REMARKS

AMENDMENTS TO THE DRAWINGS

The attached three sheets of drawings include changes to Figures 9F, 11A, 11B and 18. These sheets, which include Figures 9A-9F, 11A-11C and Figure 18, respectively, replace the original sheets including Figures 9A-9F, 11A-11C and Figure 18.

**FIG. 11A****FIG. 11B****FIG. 11C**

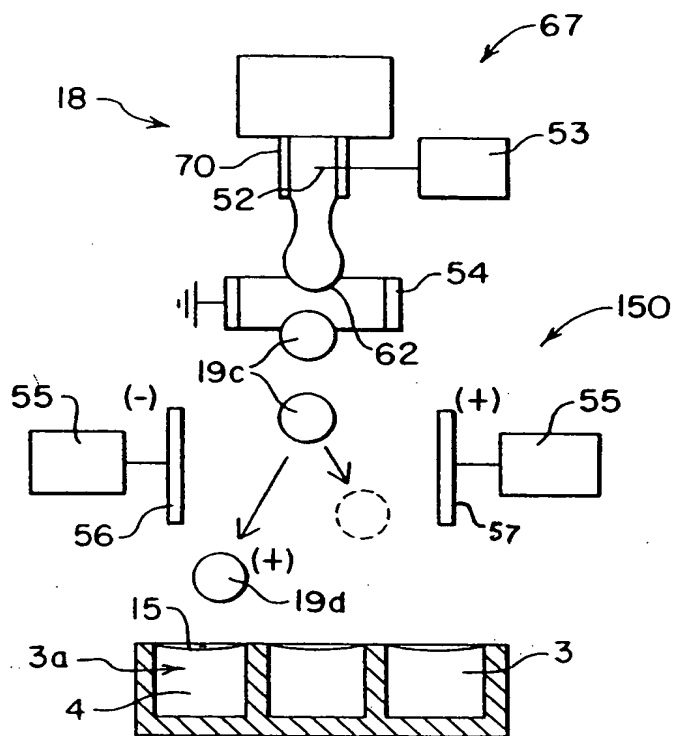
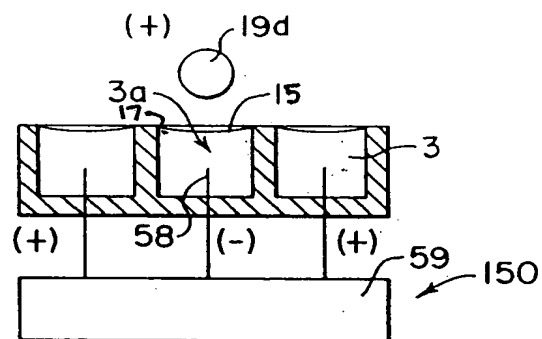
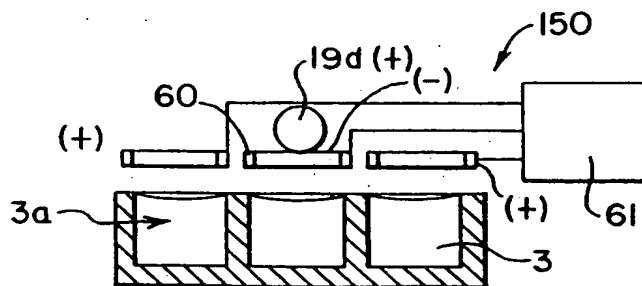
Regarding the objection to the drawings for failing to comply with 37 CFR 1.84(p)(5), Applicants have amended the drawings and specification to address the Examiner's concerns. Specifically, Applicants have amended the paragraph describing Figure 11c, beginning on page 28, line 29 and extending to page 29, lines 8 to change the phrase "targeting electrode 61" to --targeting electrode 60--, which is consistent with Figure 11c. Applicants also amend Figure 11A to include reference sign 57, Figure 11B to include reference signs 15 and 17 and Figure 18 to include reference sign 181. In addition, Applicants amend Figure 9F to move the reference arrow for virtual wall 15 to point to the lower meniscus forming the virtual wall, rather than the encapsulant 66.
